Staff Report

Infill Housing Design Review Committee

File Number: 1-A-24-IH

Location: 1543 Connecticut Ave. **Parcel ID** 81 P G 038
Zoning: RN-2 (Single-Family Residential Neighborhood)
District: Lonsdale Infill Housing Overlay District

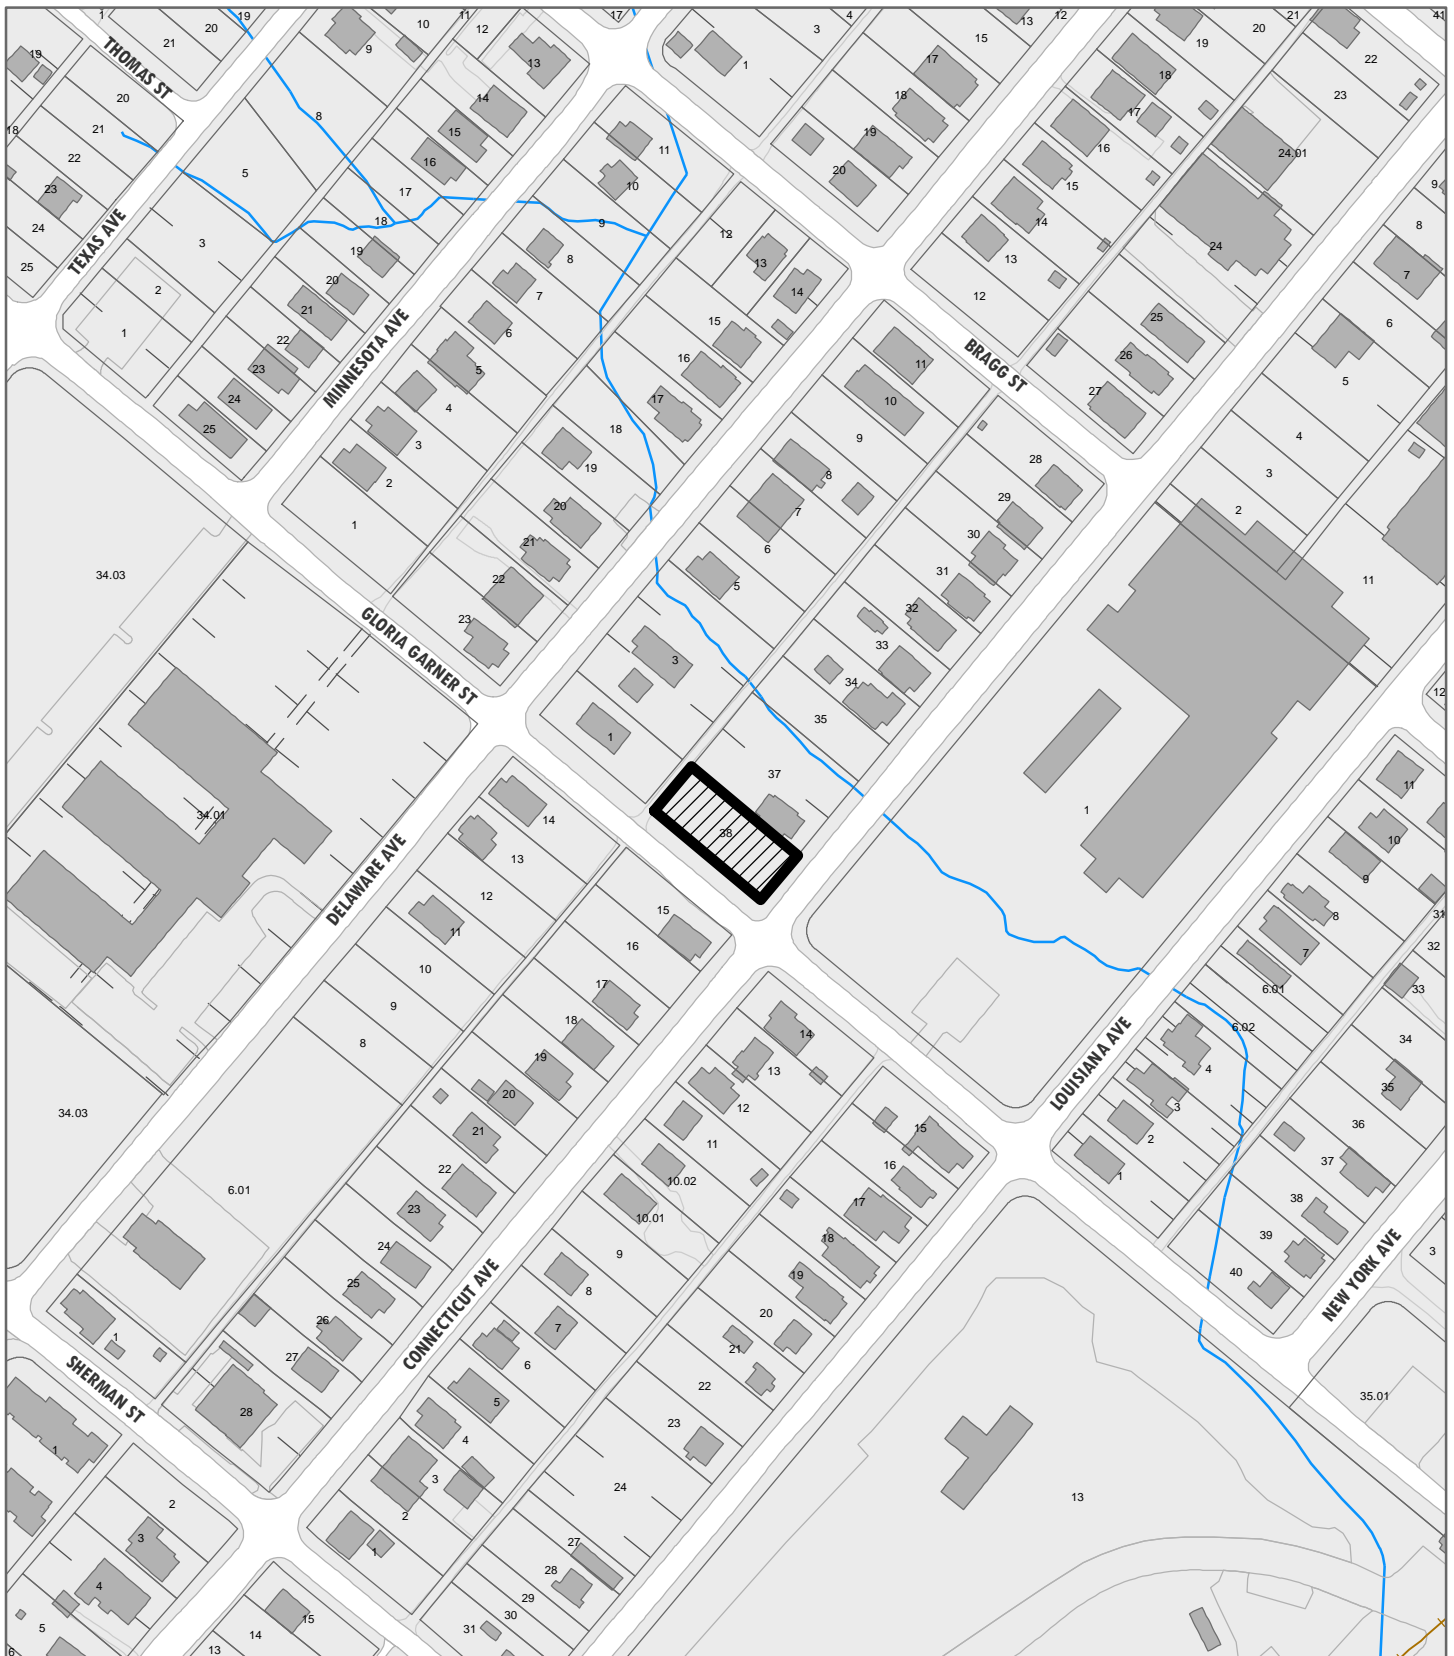
1. The proposed front setback is not clarified on the site plan, but shown as significantly recessed from the 20' front setback requirement. The average front setback of the blockface is 20.5', with the adjacent house at 16'. The house should be moved towards the front property line to align with the blockface. The site plan includes a walkway to the sidewalk.

2. The block to receive new construction is characterized by modified Queen Anne cottages and infill construction. The one-story, three-bay house is proportional to the dimensions of the lot and the context of the block.

3. The proposed parking meets the Infill Housing zoning code and design guidelines, accessed from an alley and located to the rear of the house. Final site plan revisions may be necessary to meet City Engineering standards.

Staff recommends approval of Certificate 1-A-24-IH, subject to the following conditions: 1) final site plan to meet City Engineering standards; 2) front setback to be revised to align with blockface; 3) final site plan to incorporate native or naturalized shade trees in the front and rear yards; 4) foundation height to measure at least 12" to be compatible with the neighborhood context.

Drawn:
 EXTERIOR ELEVATIONS

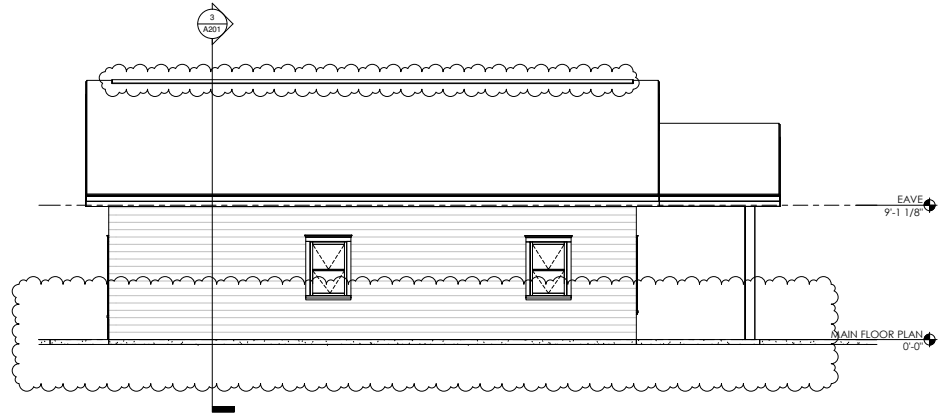
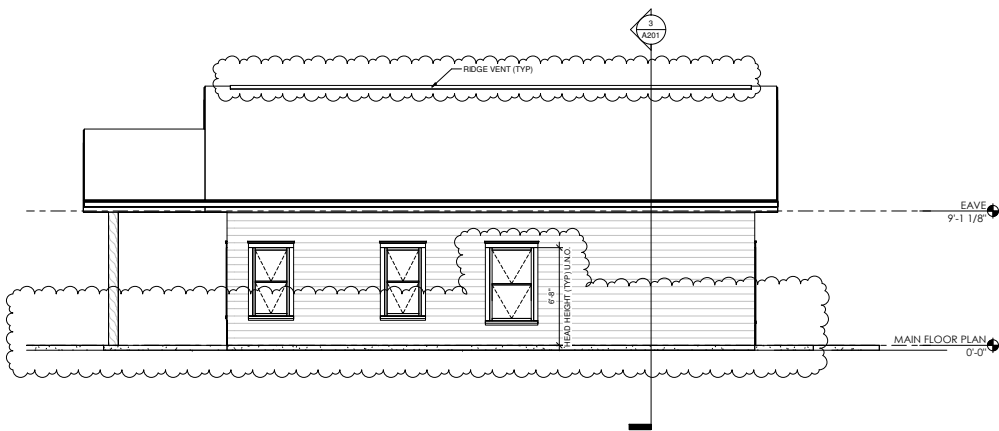
4. The house's façade is similar in scale and width to historic houses on the block and neighborhood. The house is proposed for a concrete slab foundation; the foundation should be elevated to at least 12"-18" to reflect foundation heights in the context.

5. The house features an 8' deep, partial-width front porch supported by 8 by 8 square columns. The porch is compatible with the design of the house and the surrounding context.

6. Guidelines recommend window and door styles be similar, with similar proportions and ratio of solid to void, to historic houses on the block. All elevations have sufficient window proportions.

7. The proposed roof pitch, 6/12, is the minimum typically approved in the Infill Housing overlay.
 8. Final horizontal siding materials should incorporate an overlap instead of Dutch lap or flush panel siding. The foundation should be clad in stucco or a parge coat instead of exposed CMU.
